# Access Compliance Report

## Public Rights-of-Way

Intersection ID: 14629	Main Street: EASTWAY_DR	Cross Street: WOODLAND_DR	Location: S
ADA ID: F24169131C2C	Ramp Type: PerpDiag	Initial Pass/Fail: Fail	Overall Compliance: No
Codes/Mitigation Info/Possible Solution		Field Measurements/Component Compliance

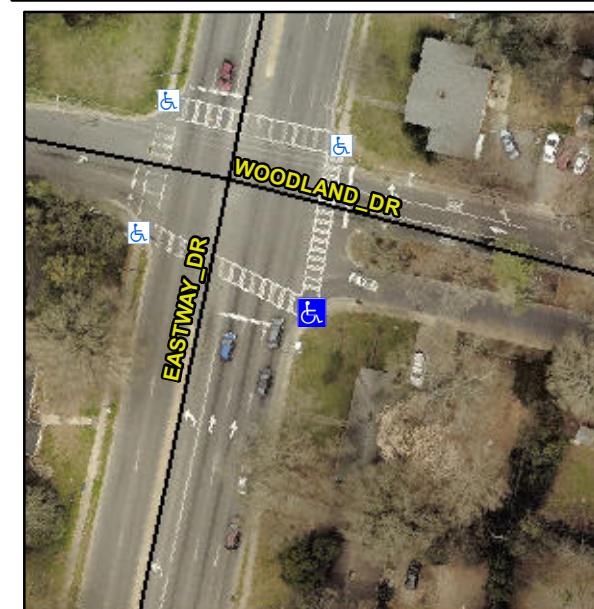
**Not Found, R304.2.2, R304.5.3**

Compliance	Description	Data	Compliance	Description	Data
N/A	Ramp Length (in)	59.0	No	Ramp Slope (%)	10.1
Yes	Ramp Width (in)	52.0	No	Ramp XSlope (%)	4.1
N/A	Flare Type LT	N/A	N/A	Flare Type RT	N/A
N/A	Flare Slope LT (%)	N/A	N/A	Flare Slope RT (%)	N/A
N/A	Flare Traversable LT?	N/A	N/A	Flare Traversable RT?	N/A
N/A	Landing Length (in)	N/A	N/A	DWS Provided?	N/A
N/A	Landing Width (in)	N/A	N/A	DWS Contrast?	N/A
N/A	Landing Slope (%)	N/A	N/A	DWS Length (in)	N/A
N/A	Landing X Slope (%)	N/A	N/A	DWS Full Width?	N/A
N/A	Landing Curb? (Y/N)	N/A	N/A	DWS Offset (in)	N/A
N/A	Shared Landing?	N/A			
N/A	Gutter Ponding?	N/A	N/A	Gutter Slope (%)	N/A
N/A	Gutter Lip Ht (in)	N/A	N/A	Gutter X Slope (%)	N/A
N/A	Painted X Walk1?	Yes	N/A	Painted X Walk2?	Yes
	X Walk 1 Direction	To NE		X Walk 2 Direction	To NW
N/A	X Walk 1 Width (in)	95.0	N/A	X Walk 2 Width (in)	113.0
	X Walk 1 Slope (%)	0.7		X Walk 2 Slope (%)	2.2
	X Walk 1 X Slope (%)	2.7		X Walk 2 X Slope (%)	0.6

**Remove & Replace Curb Ramp With Two New Directional Ramps or Equivalent.**
